REFERENCE: P/25/98/BCB

LOCATION: Corneli Primary School Greenfield Terrace North Cornelly CF33 4LW

PROPOSAL: Demolition of the two existing primary schools, construct a new Welsh Medium Primary School building with associated infrastructure and landscape works (amended plans showing revised coach drop off and pick up from hall drive and removal of the coach drop off and pick up from Greenfield Terrace and additional noise details)

Addendum Report P/25/98/BCB

01 May 2024 – 1516

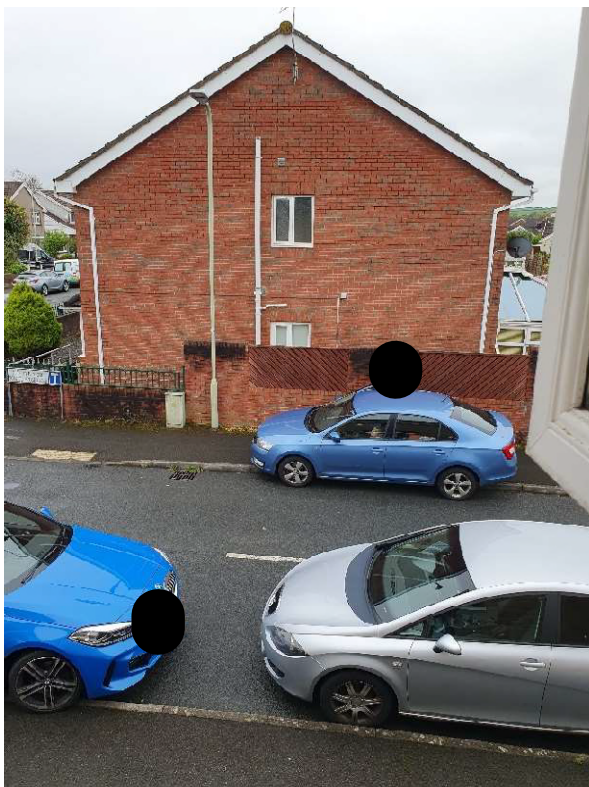
All 5 vehicles in breach of waiting prohibition. Note time of day.

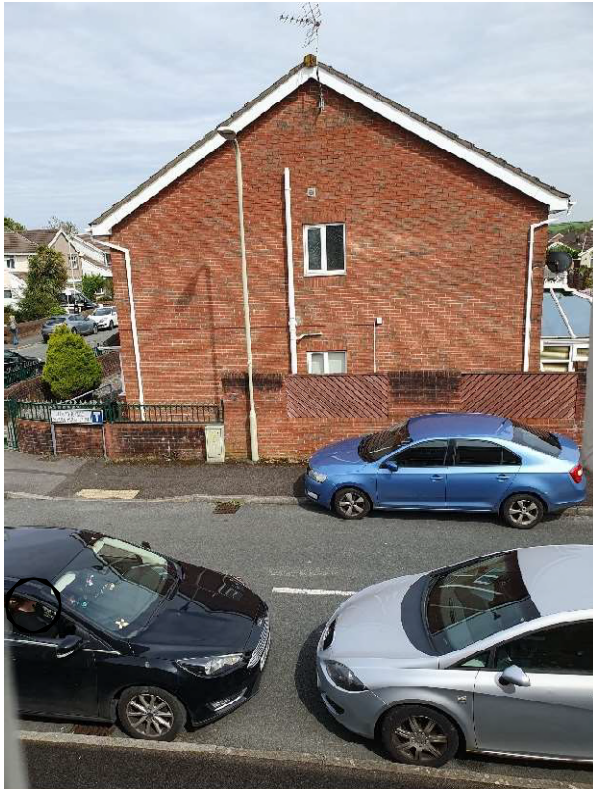
Illustration of waiting restriction. The Mon-Fri nature can only relate to the proximity to the school, yet it is never enforced now.

24 May 2024 – 1037

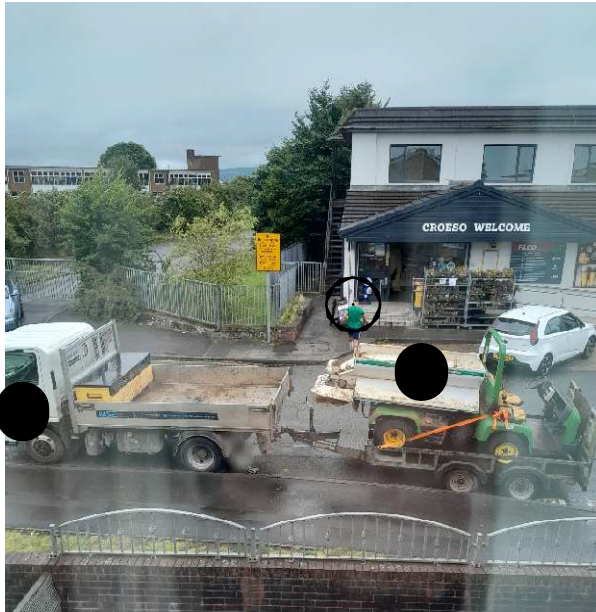
Blue/black car parked on corner of junction. Silver car parked totally across the egress from the junction.

30 Aug 2024 – 1219

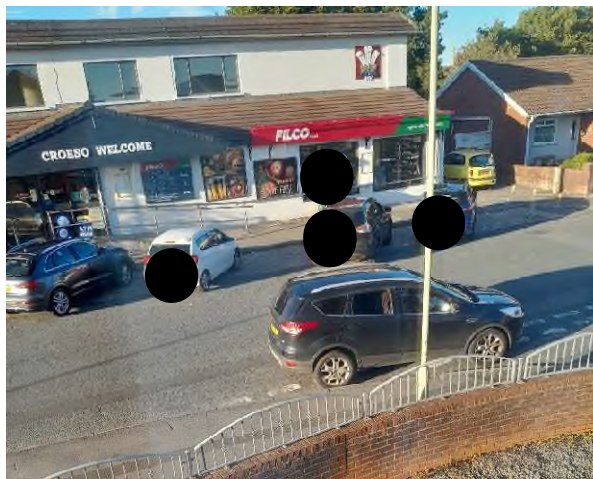
Unloading lorry parked on kerb in Hall Drive using unregistered fork lift vehicles to unload. Neither fork lift will have Road Traffic Act insurance.

08 Oct 2024 – 1244

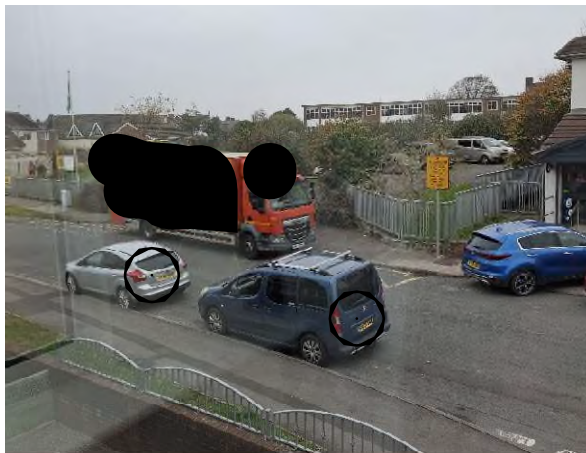
Unloading across junction.

13 Dec 2024 – 1307

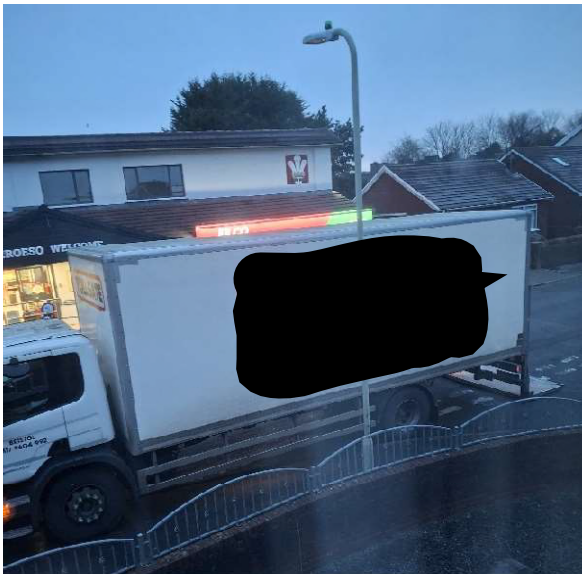
Almost completely obstructing the pavement ...I had difficulty getting in and out of my front gate.

... and partially obstructing the dropped kerb. Not much use to a wheelchair user.

20 Jul 2025 – 1225

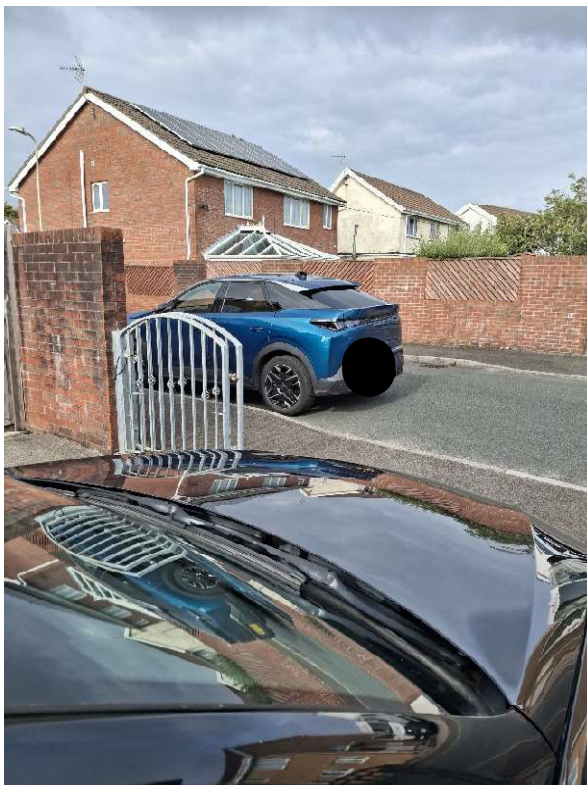
Emergency vehicle access compromised.
